Notification Subject: PCN for WF80

- Issue Date : April, 25th, 2022
- Description : WF80 Driver IC Nova NT39419 NT52001 EOL.
- Effect of Change : WF80B, WF80P, WF80Q Series
- Action Plan: Winstar finished testing and planning alternative IC FITI for further production units.
- Appearance Difference : Yes
- Function Difference : No
- Planning Changing Time : Immediately.

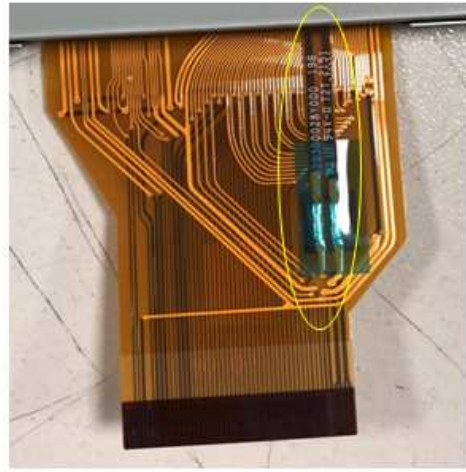
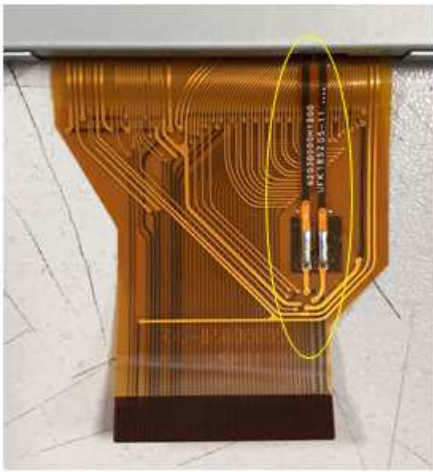
Before Change	After Change
IC : Nova S: NT39419 G: NT52001	IC : FITI S: EK9713 G: EK73002

FPC adds a QR code

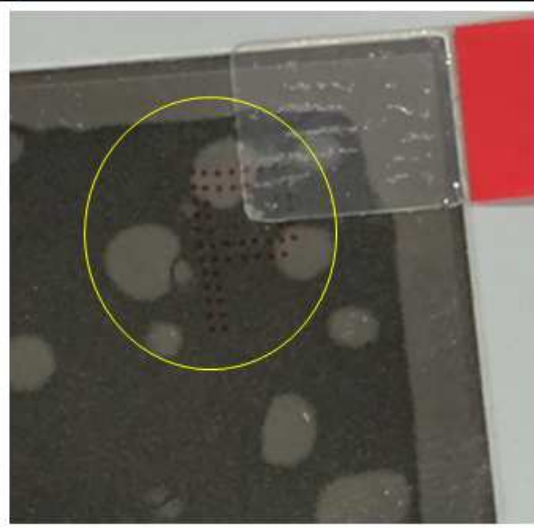
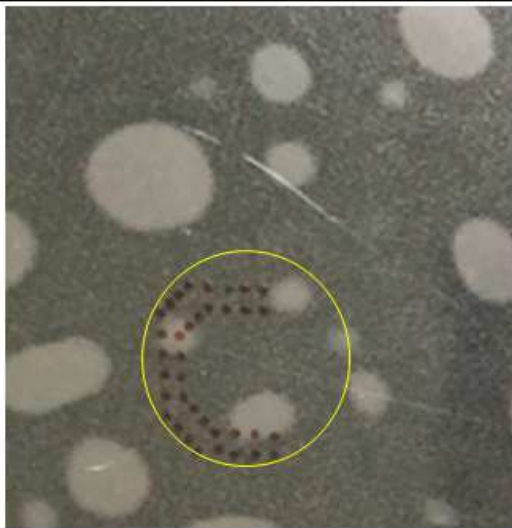
FPC adds a solder mask tape

Protective film printing changes from "C" to "P"
